The Calcutta Gazette

WEDNESDAY, OCTOBER 25, 1922.

Notices to Mariners.

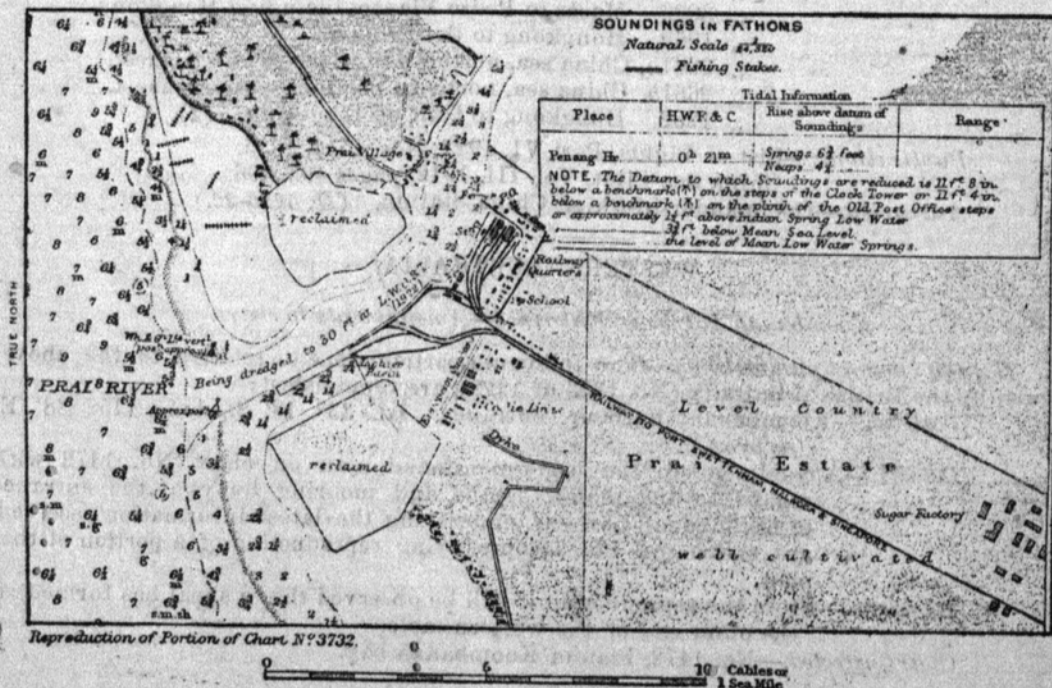
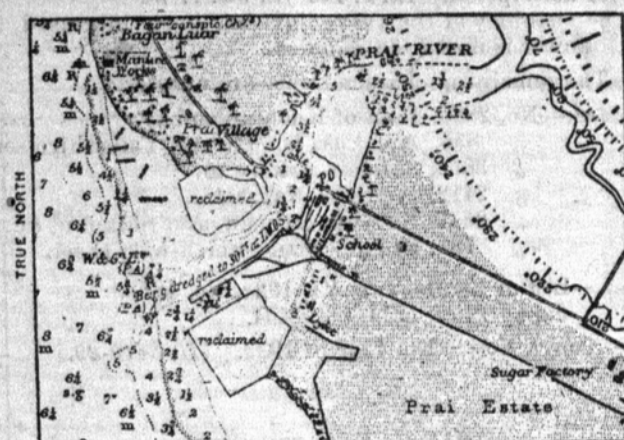
Details.—General amendments to the charts in regard to Prye river entrance, embodying the latest information received, are shown on the accompanying reproductions of portions of charts Nos. 3732 and 1366.

Reproduction of Portion of Chart No 1970.

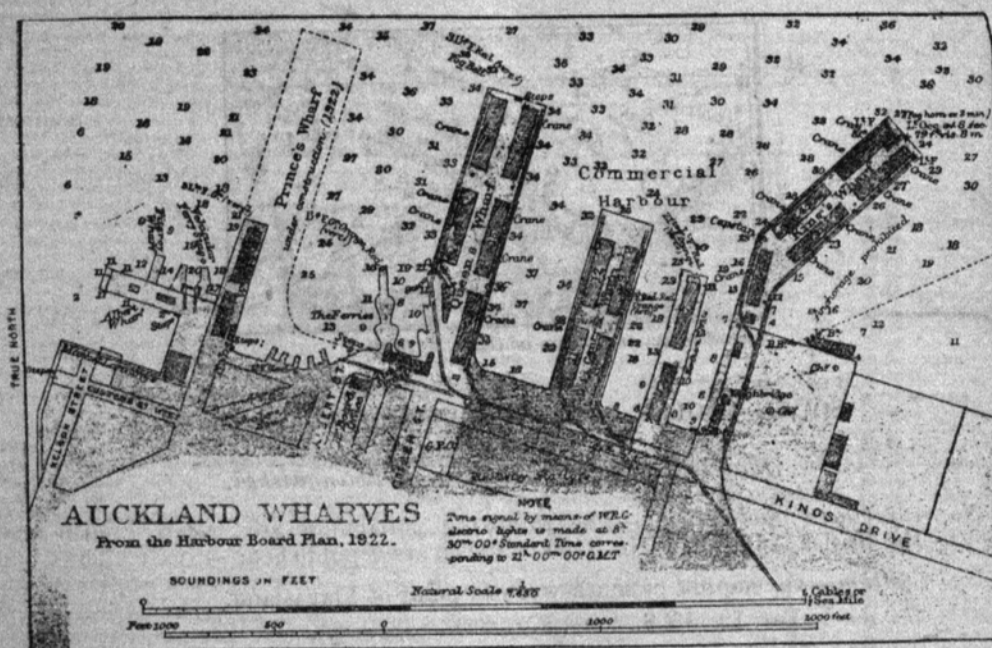
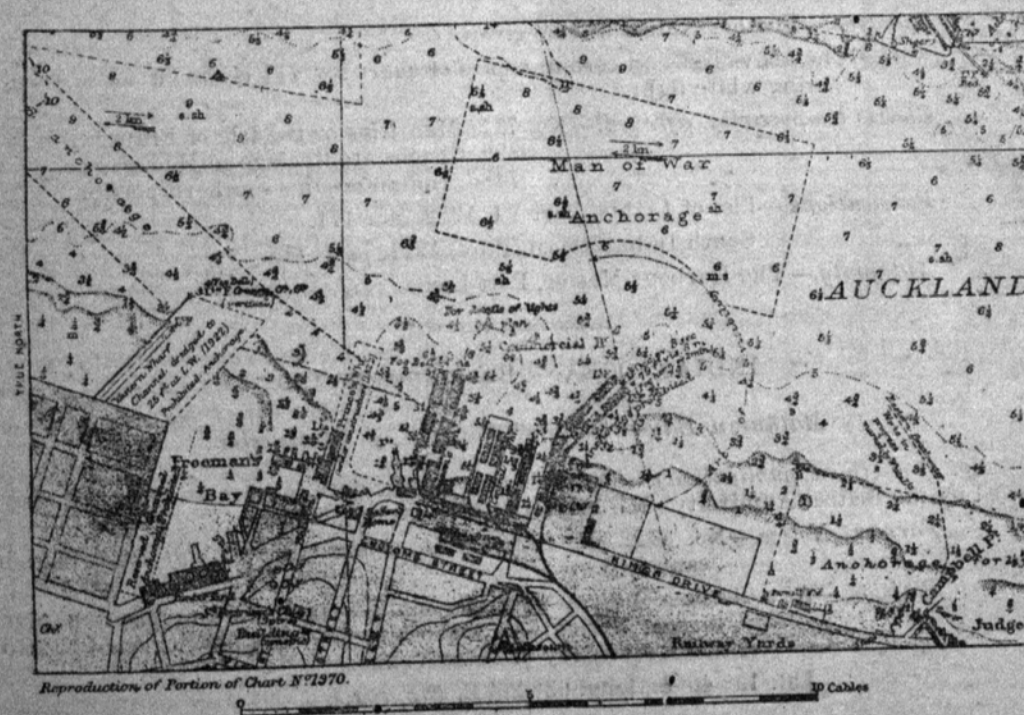
Details.—The accompanying reproductions of portions of charts Nos. 1970 and 1896 show necessary amendments to the charts with regard to wharves and depths at Auckland, also amended depths in the approaches to Calliope dock at Devonport.

Note.—From the reproductions it will be seen that a *fixed white* light now marks the new Western wharf at Auckland.

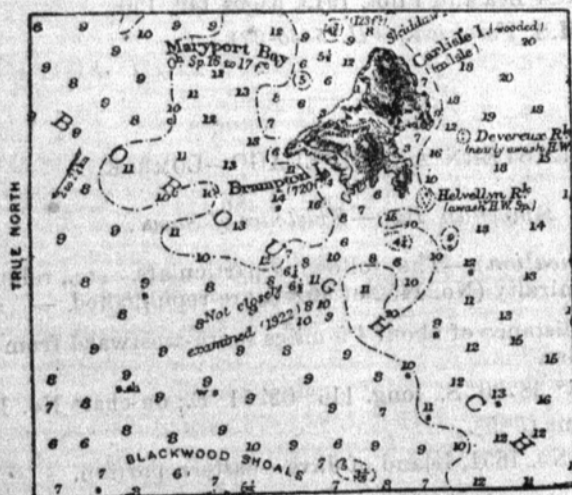
Details.—The accompanying reproduction of a portion of chart No. 347 shows the necessary amendments to the chart with regard to decreased depths south-westward of Brampton island.

Reproduction of Portions of Chart No. 2089.

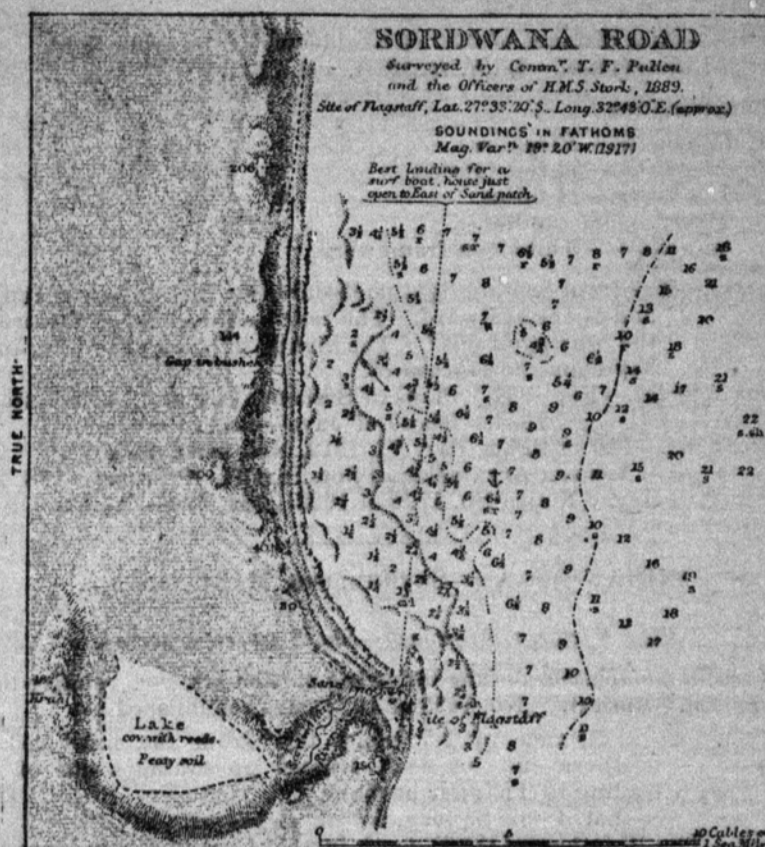
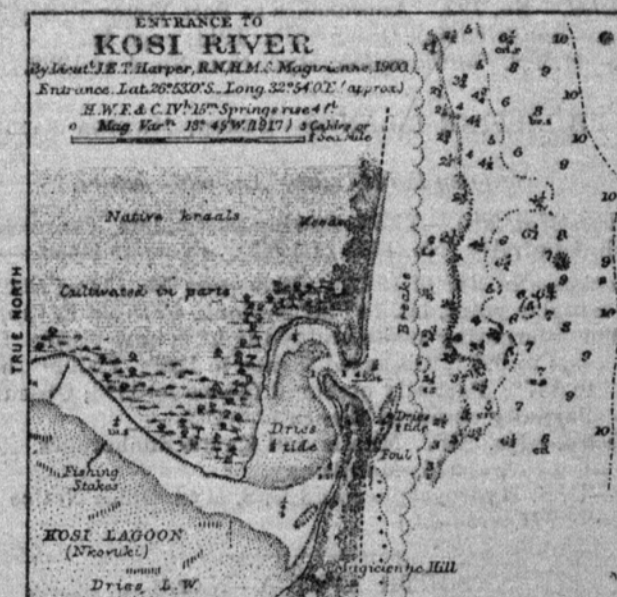
Details.—The accompanying reproduction of the plans of Sordwana road and entrance to Kosi river on chart No. 2089 shows the necessary amendments to the chart with regard to shoals and depths in the two localities referred to.

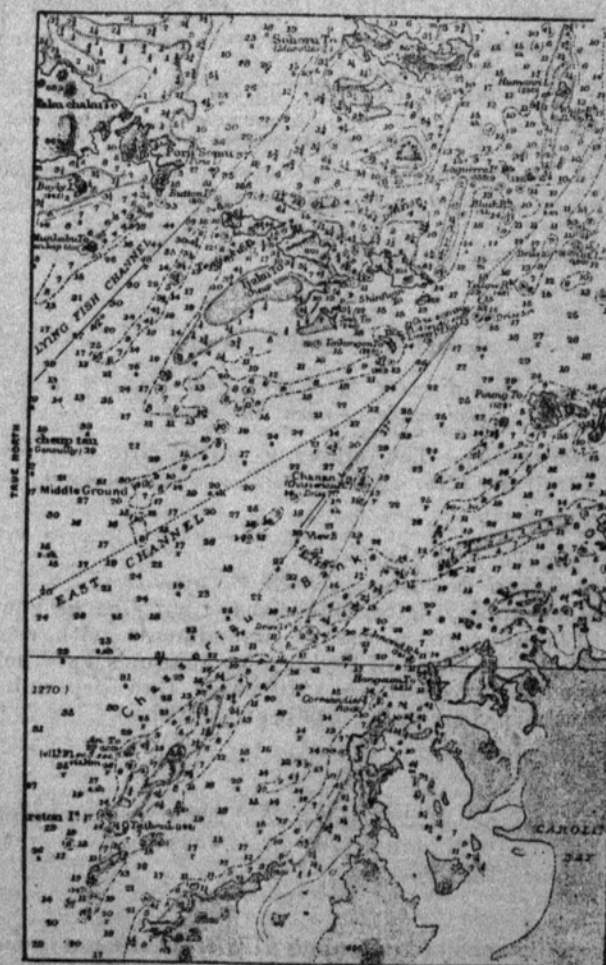
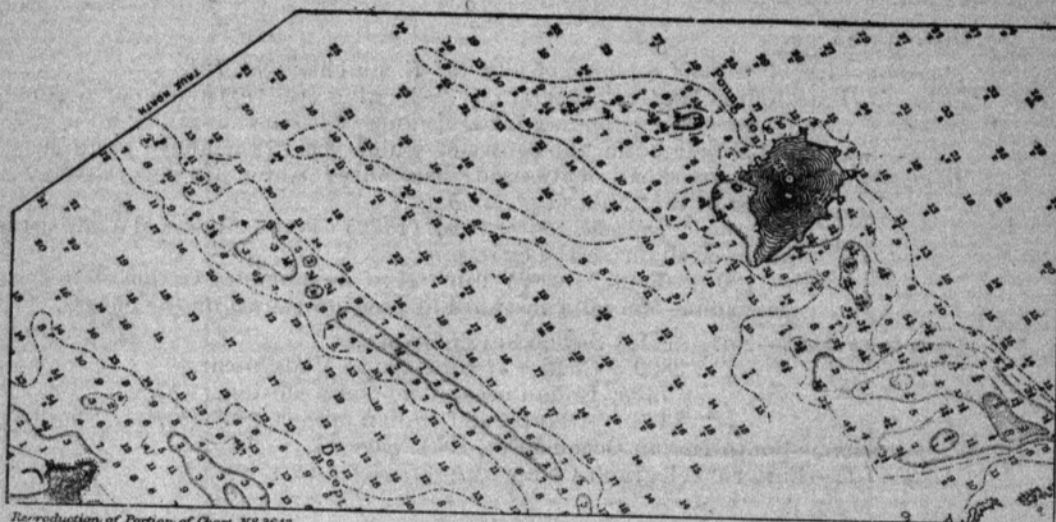
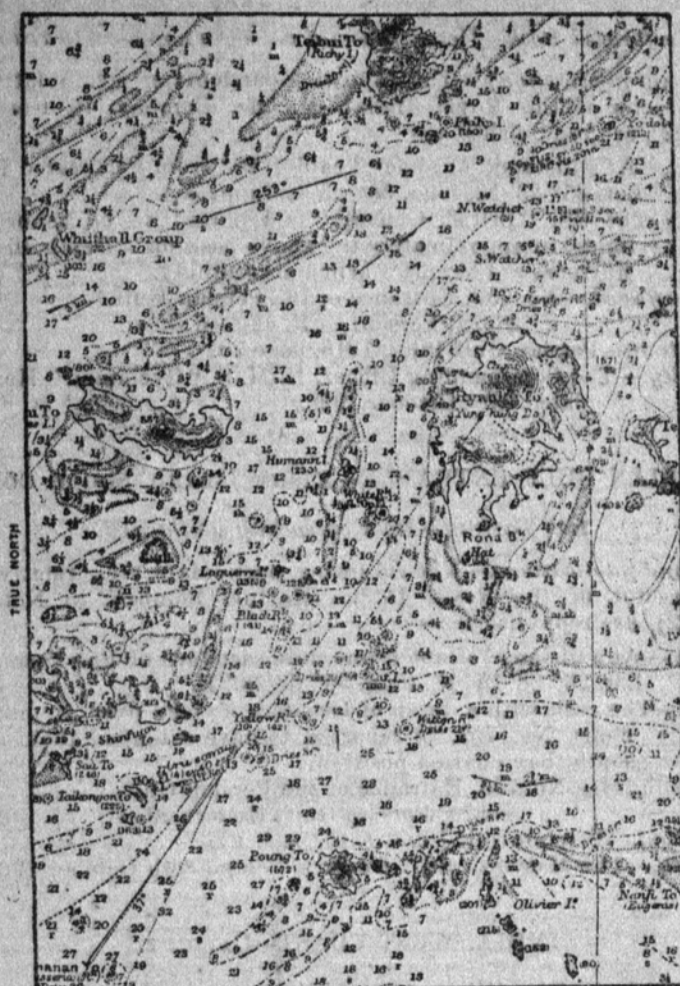
Details.—The accompanying reproductions of portions of charts Nos. 3642 and 1258 show the necessary amendments with regard to depths and shoals in East and Flying Fish channels and their vicinities.

Remarks.—The above rock and shoal, which are to be inserted on chart No. 3642, are not included in the reproduction of the portion of that chart.

Reproduction of Portion of Chart N° 1472.

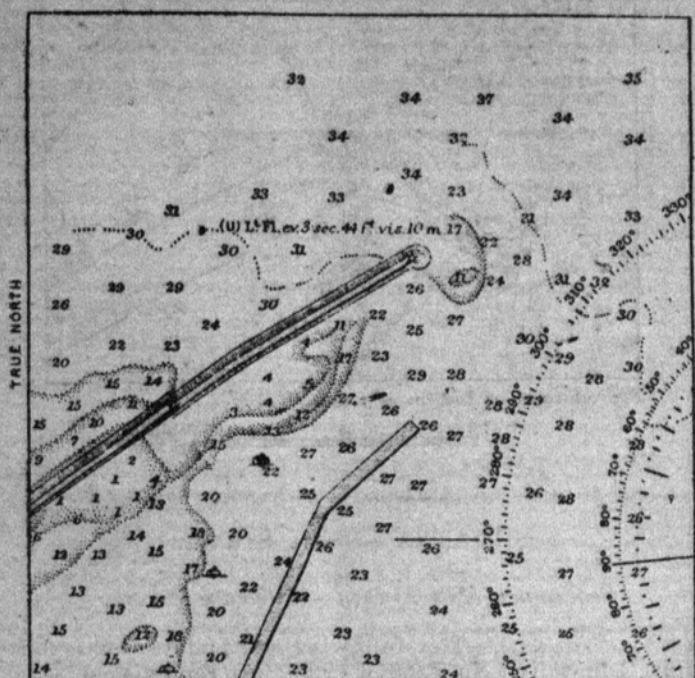
Details.—Amendments to the undermentioned plan on chart No. 1472 with regard to the moles, depths and mooring buoys at the entrance to Koombanah harbour, embodying the latest information received, are shown on the accompanying reproduction of a portion of that plan.

Reproduction of Portion of Chart N° 3732.

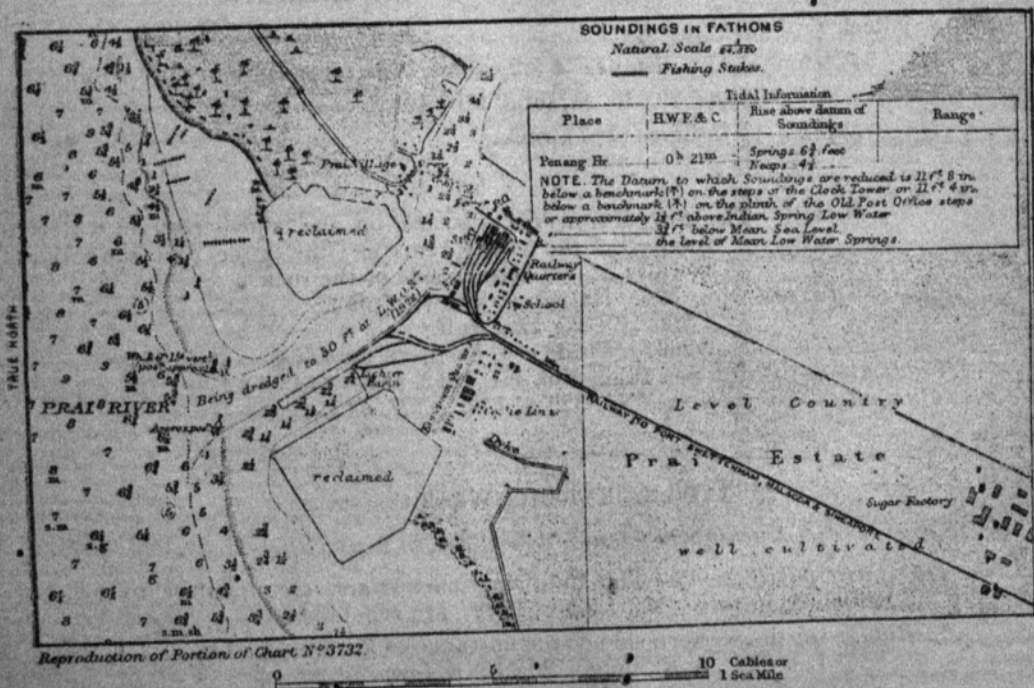
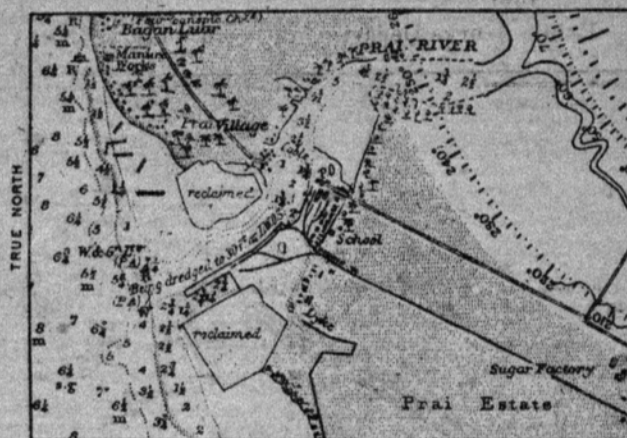
Details.—General amendments to the charts in regard to Prye river entrance, embodying the latest information received, are shown on the accompanying reproductions of portions of charts Nos. 3732 and 1366.

Reproduction of Portions of Chart No. 2089.

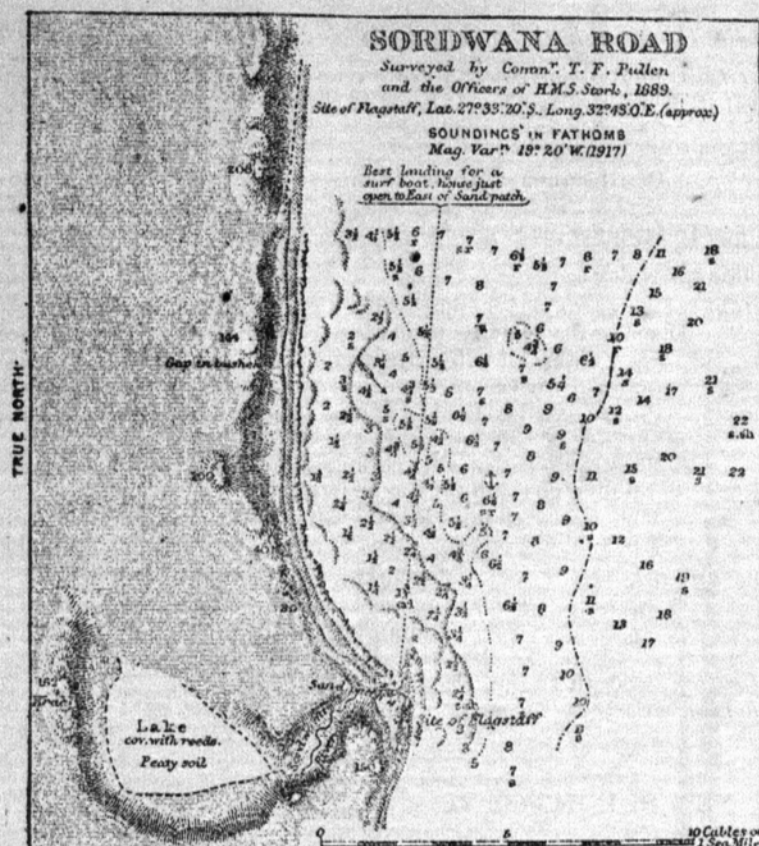
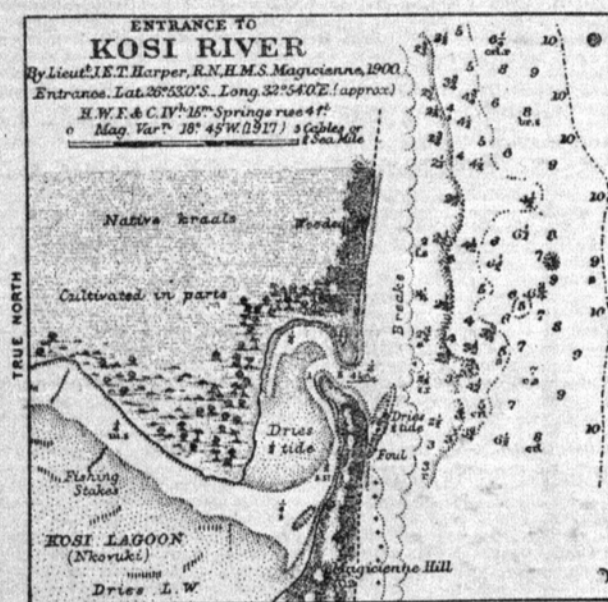
Details.—The accompanying reproduction of the plans of Sordwana road and entrance to Kosi river on chart No. 2089 shows the necessary amendments to the chart with regard to shoals and depths in the two localities referred to.

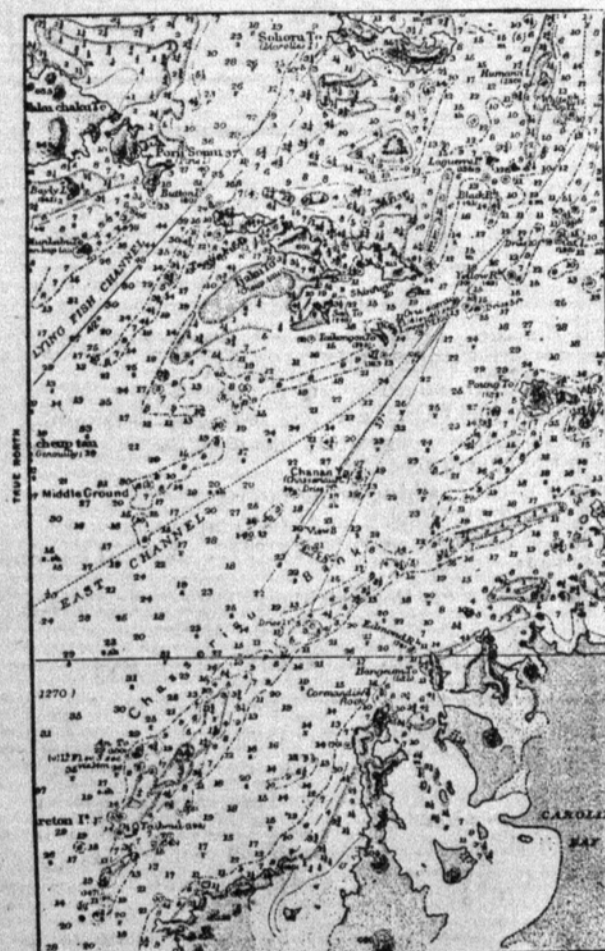
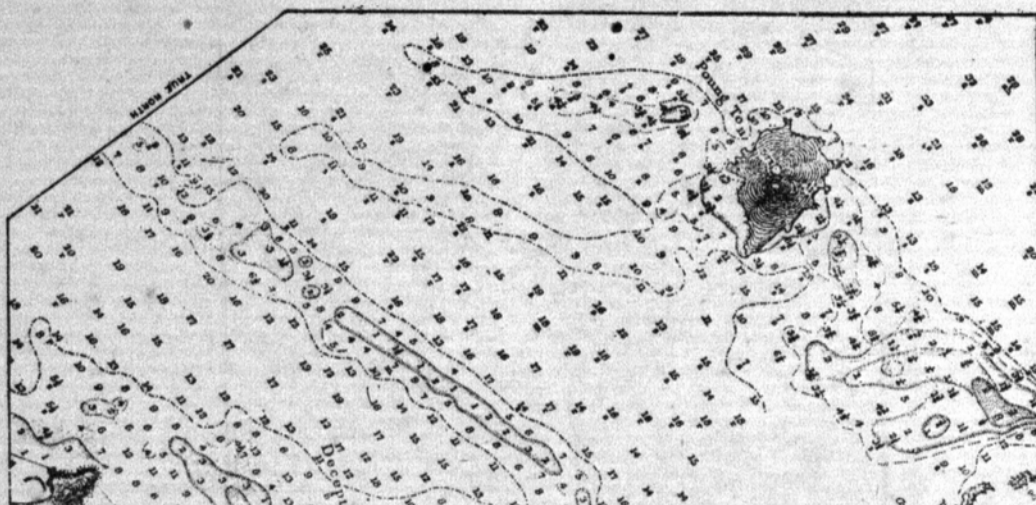
Details.—The accompanying reproductions of portions of charts Nos. 3642 and 1258 show the necessary amendments with regard to depths and shoals in East and Flying Fish channels and their vicinities.

Remarks.—The above rock and shoal, which are to be inserted on chart No. 3642, are not included in the reproduction of the portion of that chart.

Reproduction of Portion of Chart N° 3440.

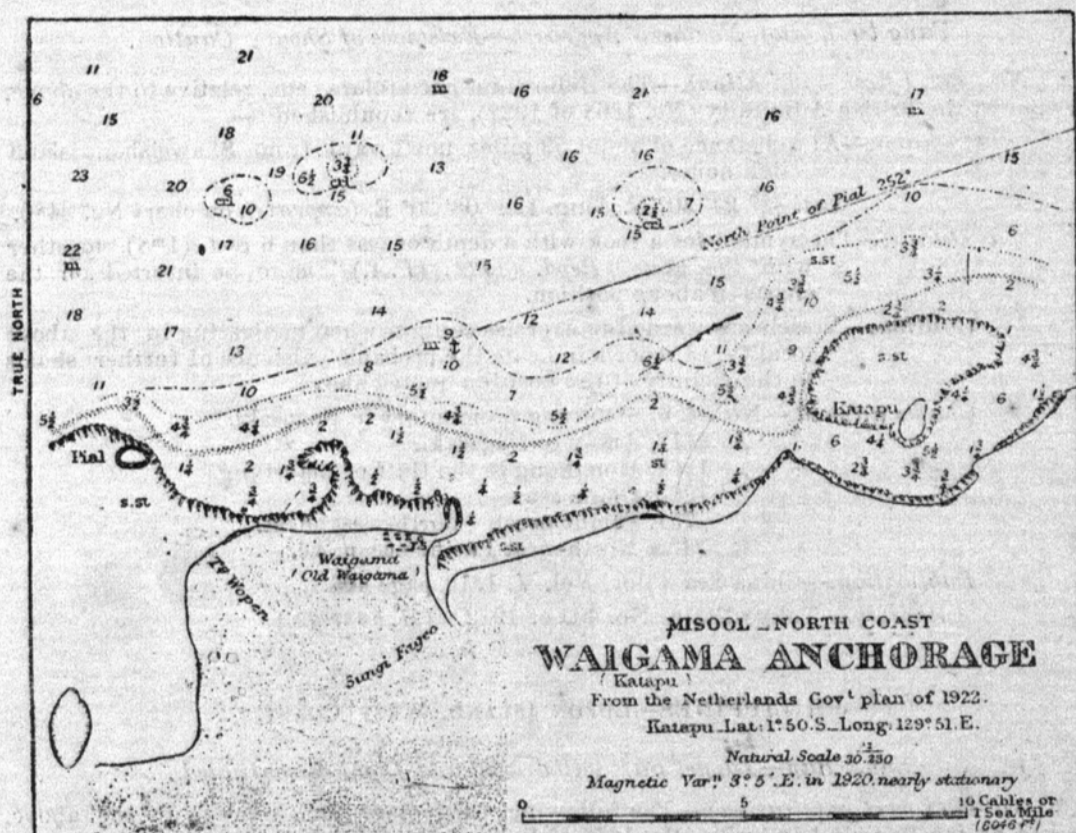
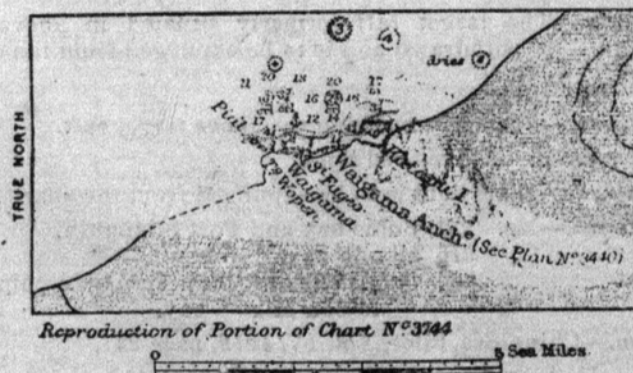
Details.—The accompanying reproduction of portions of charts, Nos. 3440 and 3744 show the necessary amendments with regard to Waigama (Katapu) anchorage. The existing plan of Katapu (New Waigama) anchorage on chart No. 3440 is to be replaced by the new plan of Waigama (Katapu) anchorage.
